## **MINISTRY OF WORKS AND TRANSPORT**

### Re: Addendum to Upgrade of Obsolete Traffic Signal Control Equipment.

#### ADDENDUM #1

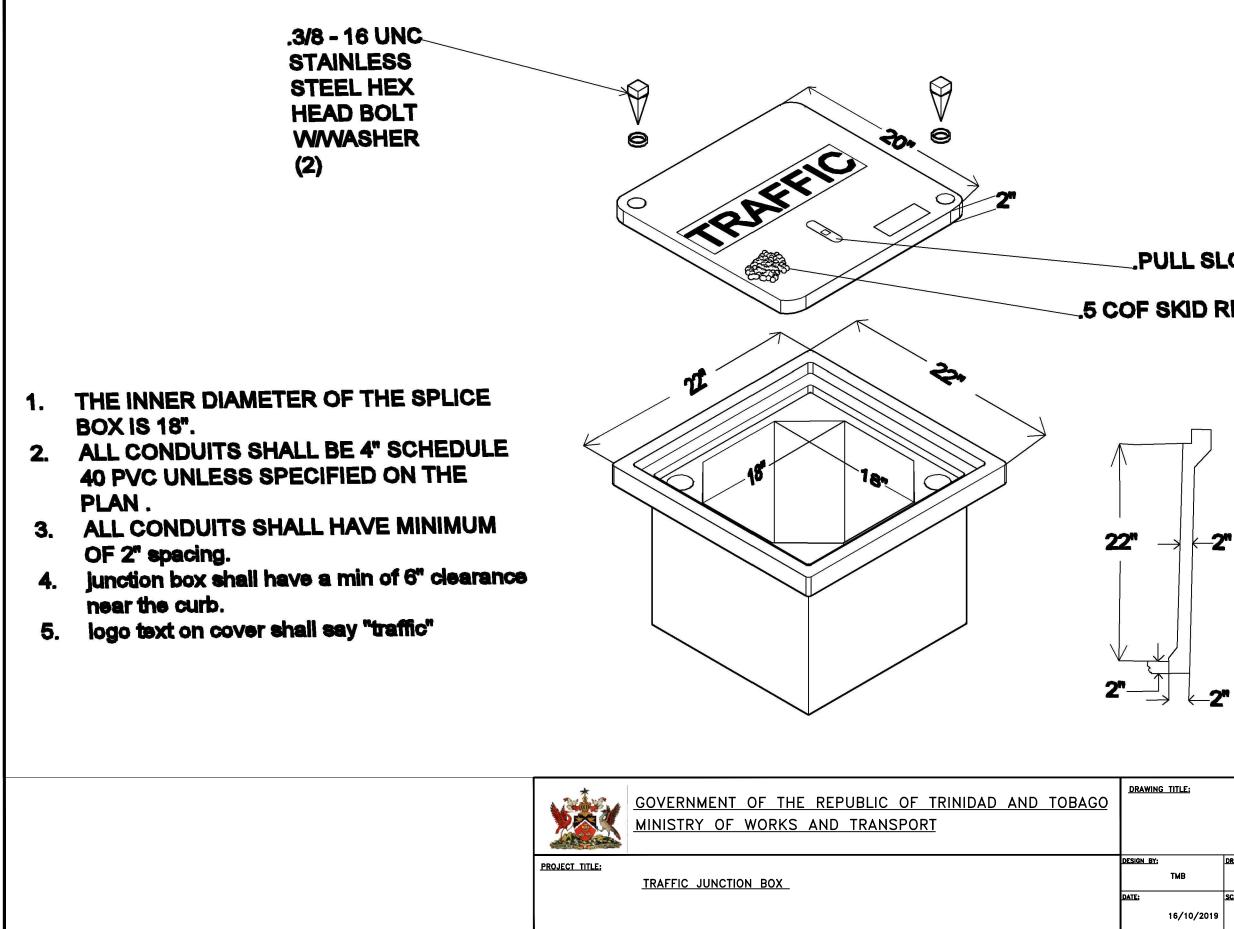
The drawings of all the locations, splice box and drilled pier foundation for the mast arm attached in the Appendix should be included as part of the Solicitation Document.
